Notice of Meeting Polk City | Planning and Zoning Commission (P&Z) *********

May 17, 2021 | 6:00 pm City Hall | Electronic Meeting **Due to Covid-19 the P&Z Commission will meet in person with Public Meeting participation via phone only Call in local 515-329-8019 Participant Code 593054 Public can provide comments directly to support**

PRELIMINARY PLAT REVIEW

Date:May 14, 2021Project:Big Creek Commons

E-8479

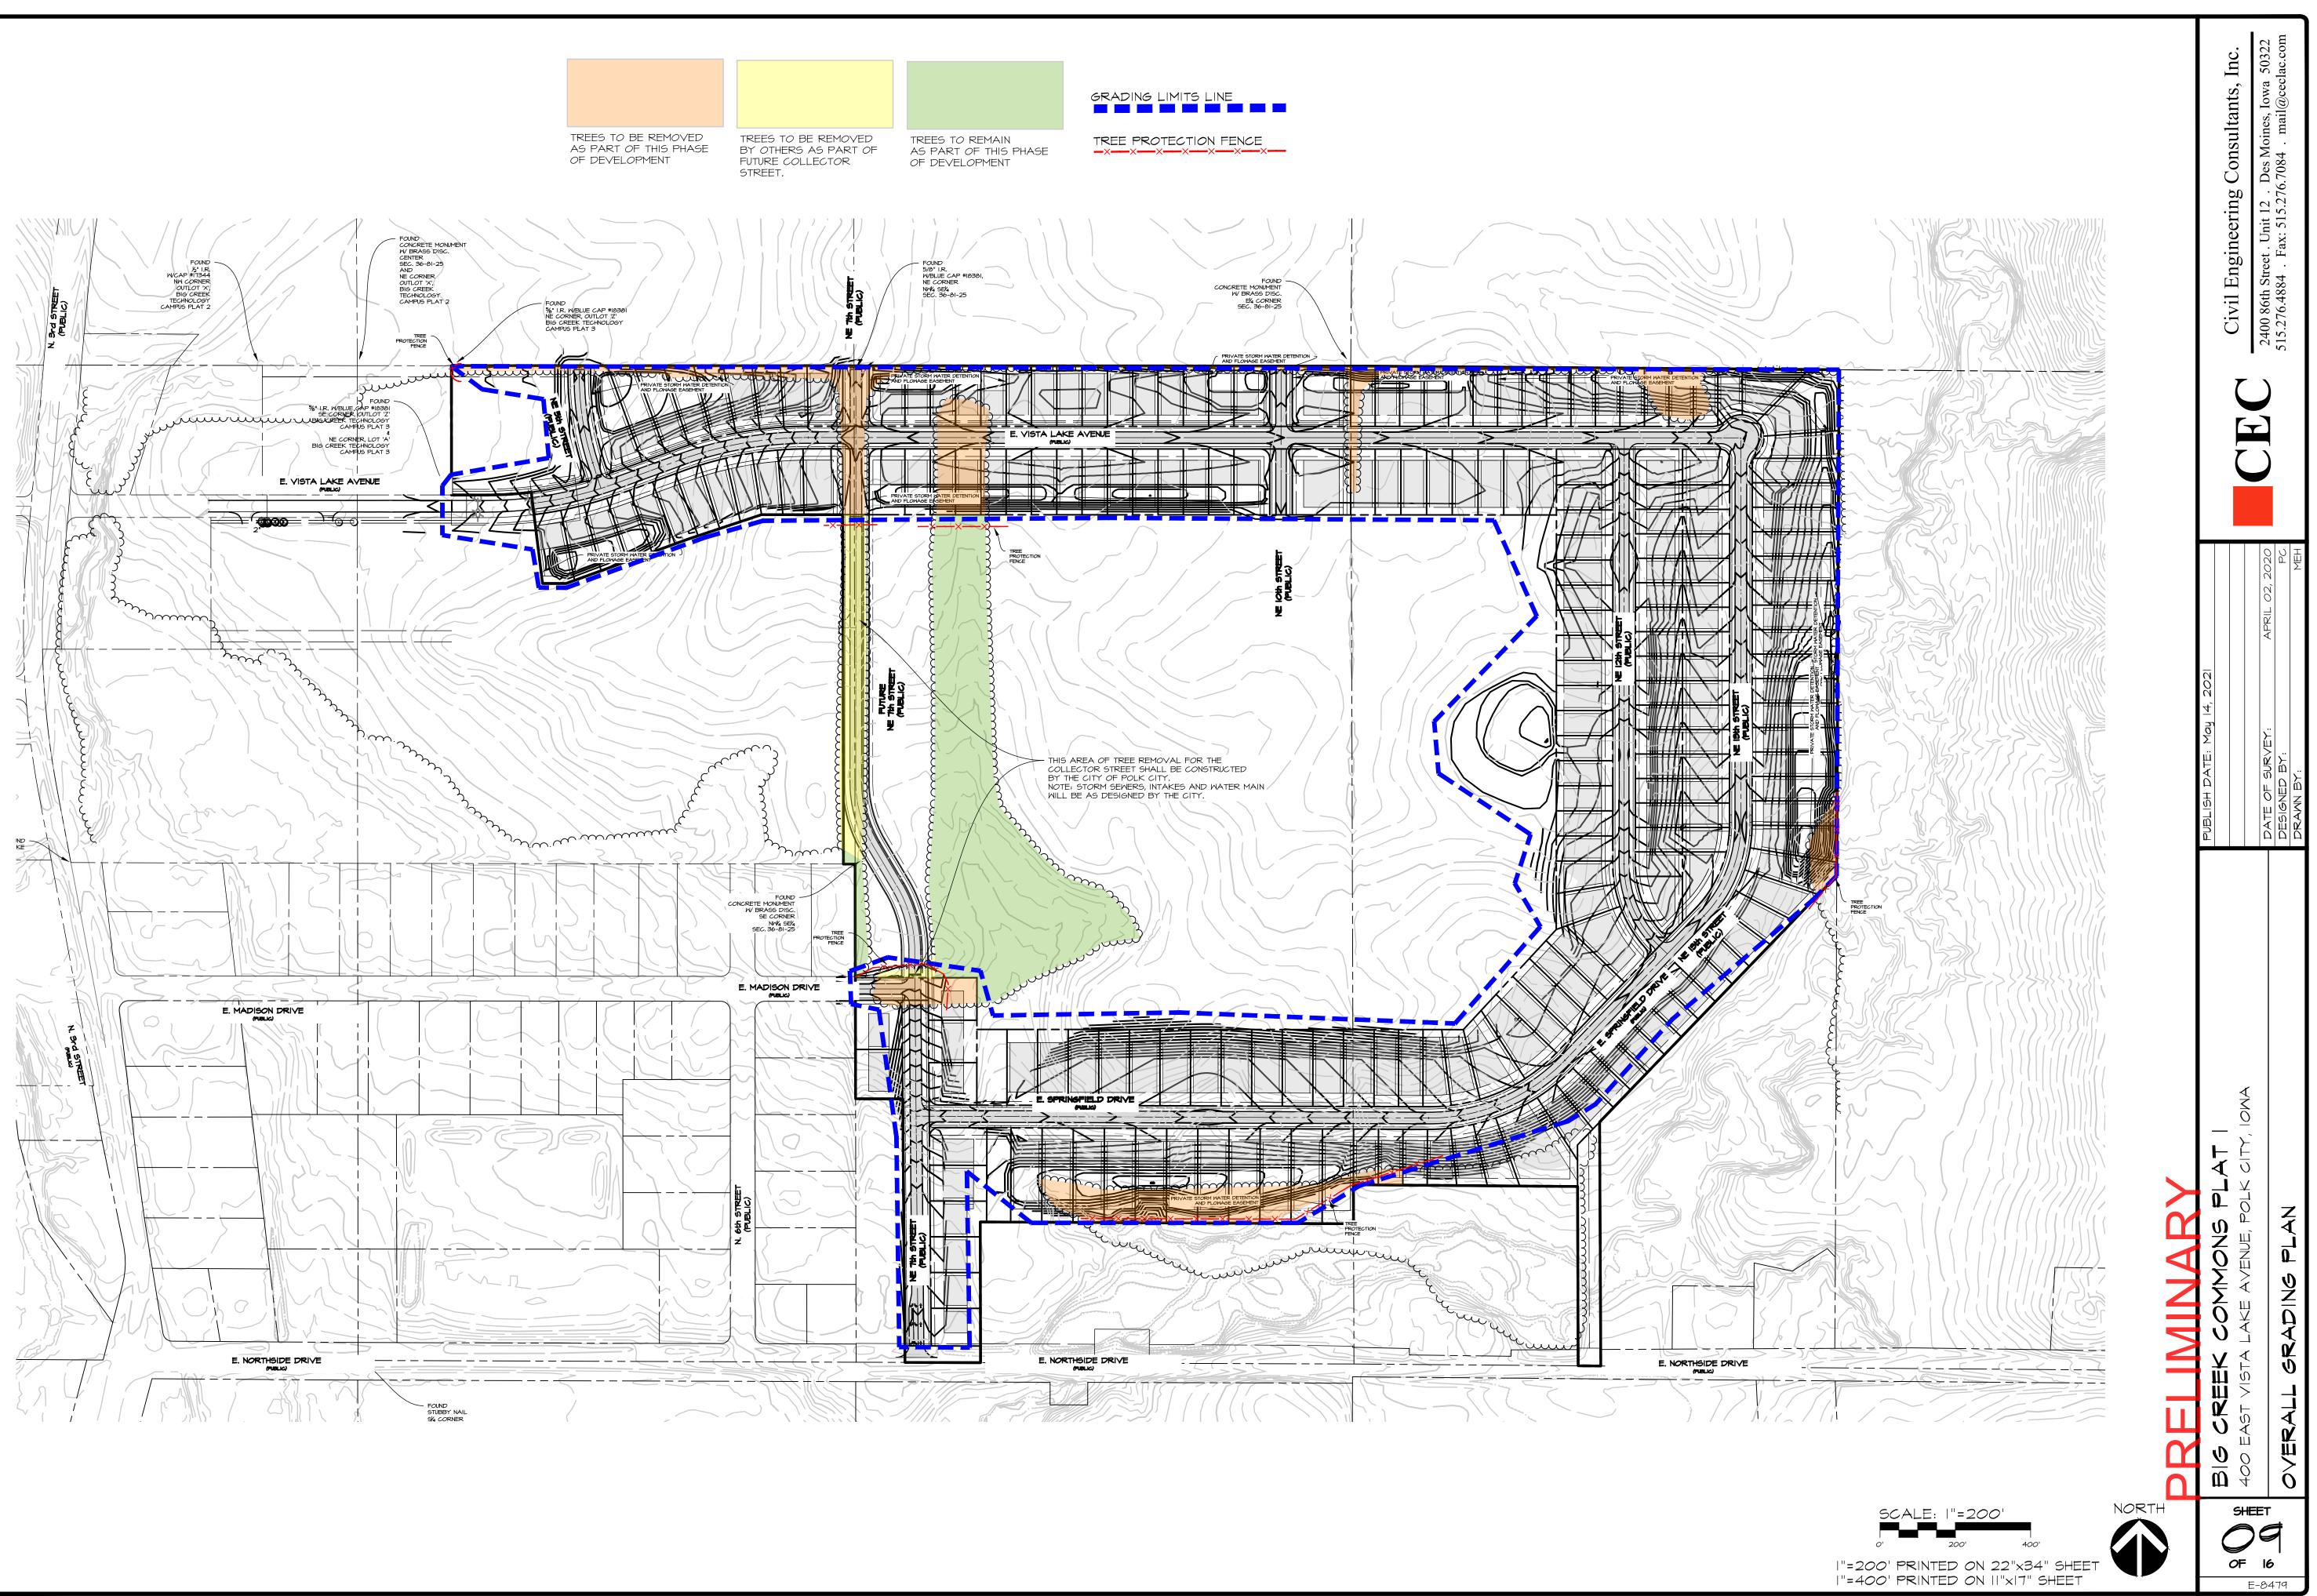
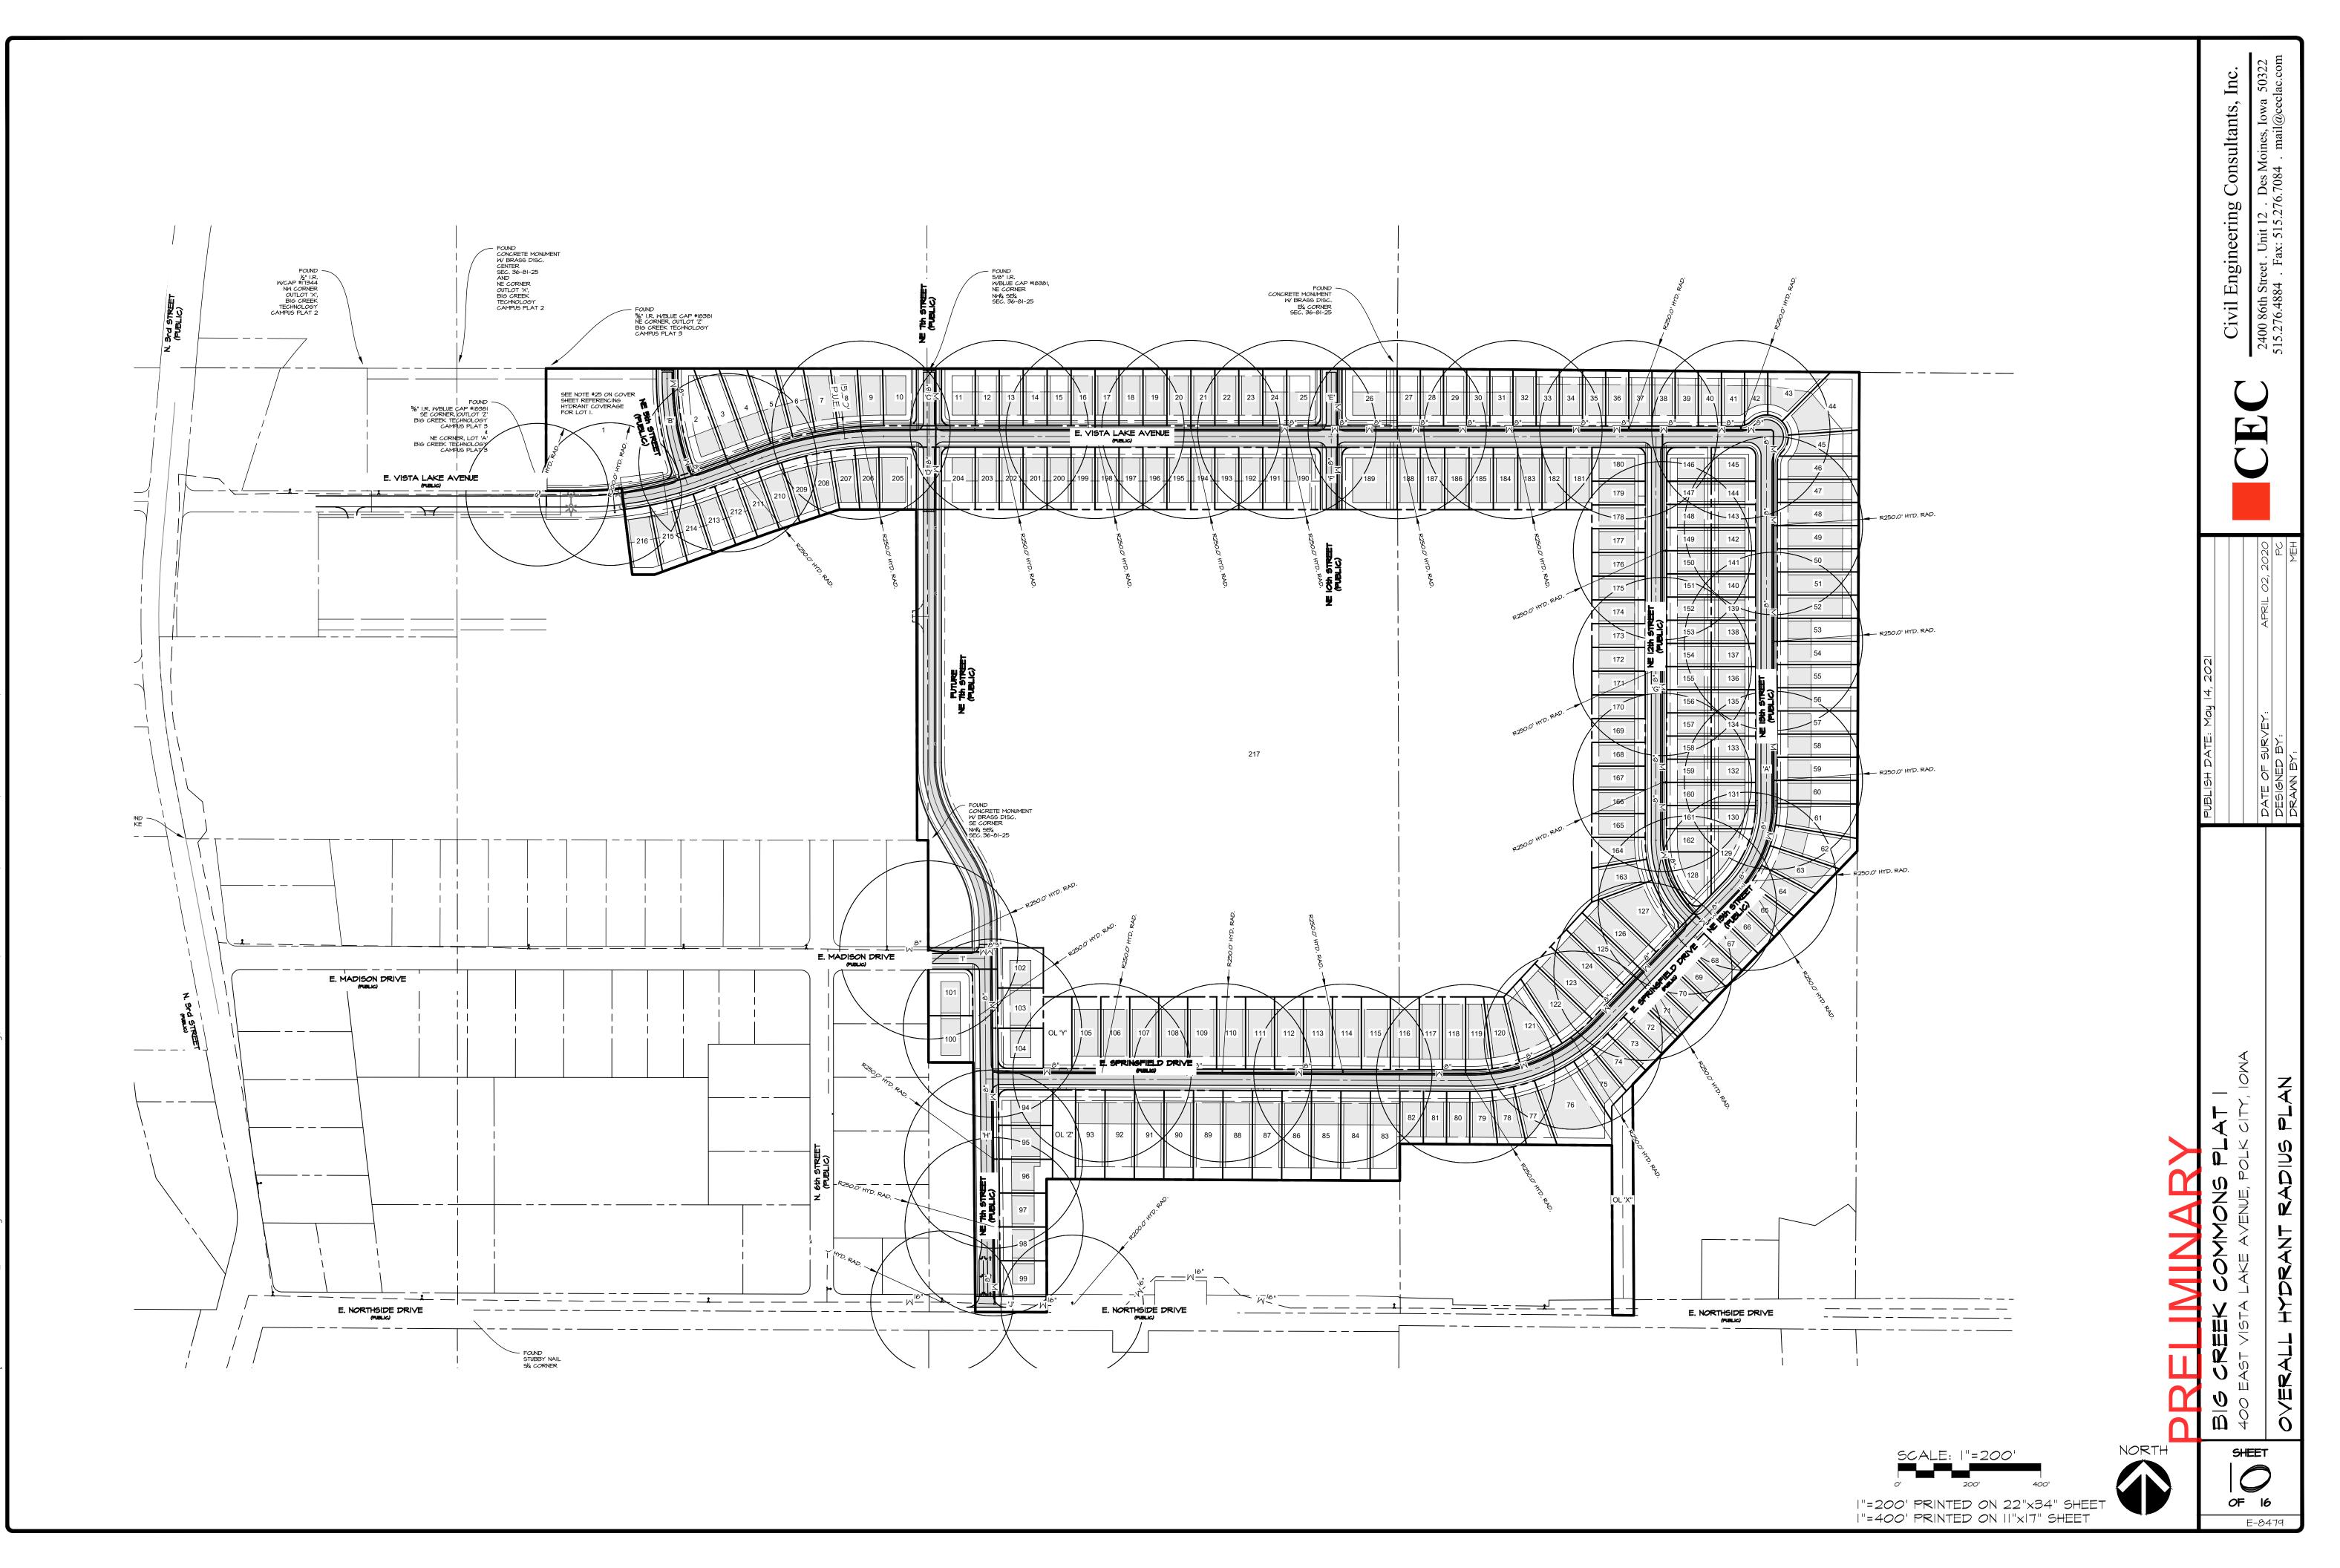
Pursuant to our review of Submittal #3, based on the Preliminary Plat, we offer the following preliminary comments.

- 1. The 10' wide trail on the north side of E. Vista Lake should be shown entirely within the 10' wide recreational trail easement rather than partially within the public right-of-way. If Council approves the elimination of the trail on the north side of E. Vista Lake Avenue, show a 5' wide public sidewalk easement in its place and show a 5' public sidewalk entirely within this easement.

- 2. Show the existing sanitary sewer easement on the south side of the plat, including book and page, and label the portion of this easement to be vacated prior to final plat approval. Show and label a proposed sanitary sewer easement on the south side of Lot 99, based on the depth of the sanitary sewer. Label the pipe as an 8" sanitary sewer.

- 3. On the future construction drawings, the sanitary sewers along the east NE 7th Street will require the developer to obtain sanitary sewer easements from the school. Alternatively, these sanitary sewers will need to be relocated such that an easement is not necessary.

- 4. It appears the layer with street grade labels and sanitary sewer slopes was turned off.
- 5. Provide a revised Storm Water Management concept addressing prior comments including updated summary table to compare pre- and post- runoff at each discharge point, updated drainage area maps with all discharge points labeled.

- 6. Revise Note #19 to refer to the construction drawings for Big Creek Commons Plat 2. Revise Note #20 to refer to Outlot X rather than Outlot V and should state the "trail easement on Outlot X will be dedicated with Plat 3 or upon the request of the City of Polk City at the time of trail construction, whichever comes sooner."
